**POTENTIAL EXPLORATION, DEVELOPMENT, AND PRODUCTION OF
OIL AND GAS RESOURCES; VANDENBERG AIR FORCE BASE, CALIFORNIA**

FINAL ENVIRONMENTAL IMPACT STATEMENT

The final EIS relies upon the analyses provided in the draft EIS. It does not repeat draft EIS information. It provides erratas for the EIS, Air Quality Technical Appendix, and MRMP. In addition, public and written comments on the draft EIS and responses are provided.

Figure 7-2

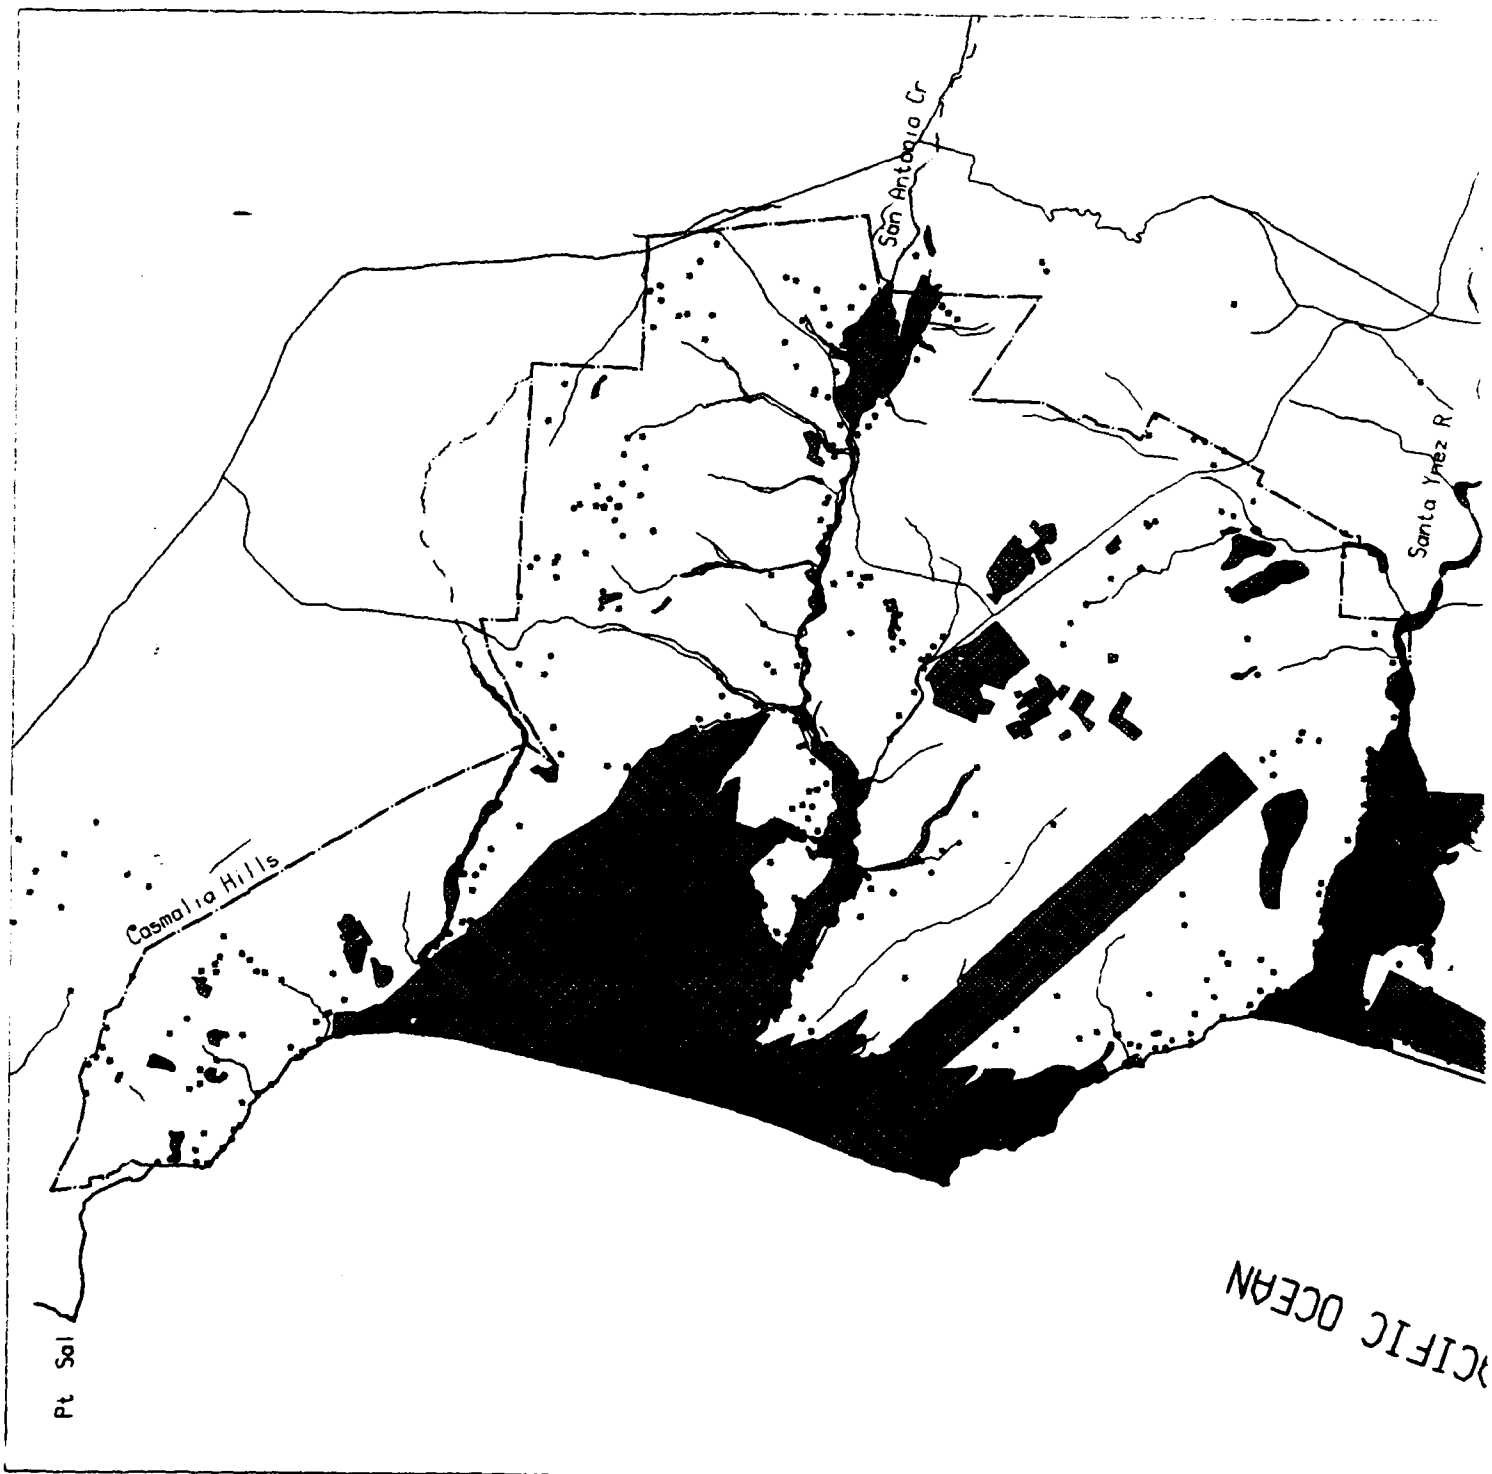
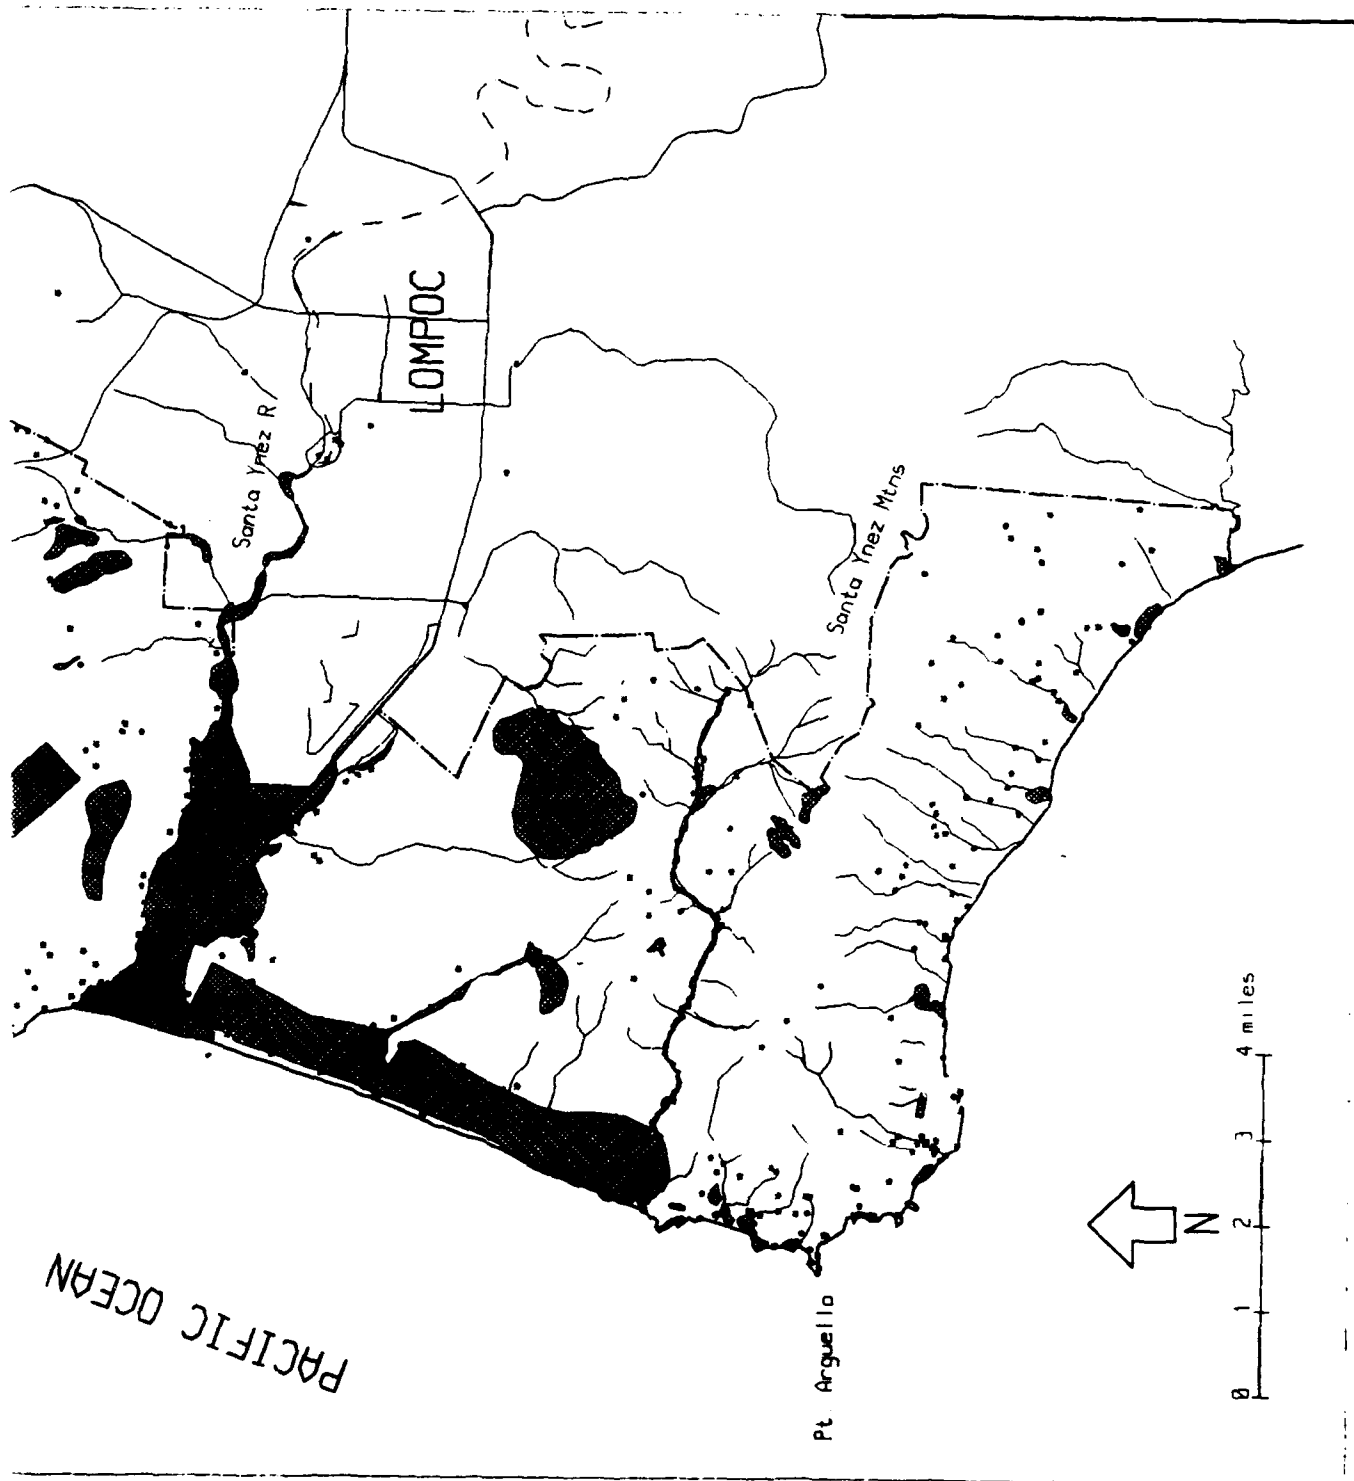
18. Figure 7.2, page 7-7. The LEGEND block is empty; either Legend text must be added, or the block must be removed. Also, this figure should include all lands within the Lompoc and San Antonio Groundwater Basins, since overdrafted groundwater resources are acknowledged in the text as a "high environmental constraint (see e.g. Sec. 6.2.4.1, p. 6.2-21, middle of first full paragraph; Sec. 7.3.3.2, p. 7-6).

- RMD-131 See the response to comment SLC-1.
- RMD-132 The legend is unnecessary and has been deleted from Figure 7-2. Please see the MRMP errata for section 7.0, Plan Criteria and Application. The referenced map gives information on locations of oil and gas facilities which may be constrained by water resource attributes. As noted in the response to comment RMD-83, the location of oil field development is not geographically tied to the location of the water source which would supply the facility. The purpose of this figure is to provide geographic information on constraints of oil and gas development on base.

A legend is unnecessary for Figure 7-2, Composite Environmental High-Constraint Areas, on page 7-7; therefore, the legend inset has been removed. See attached figure.
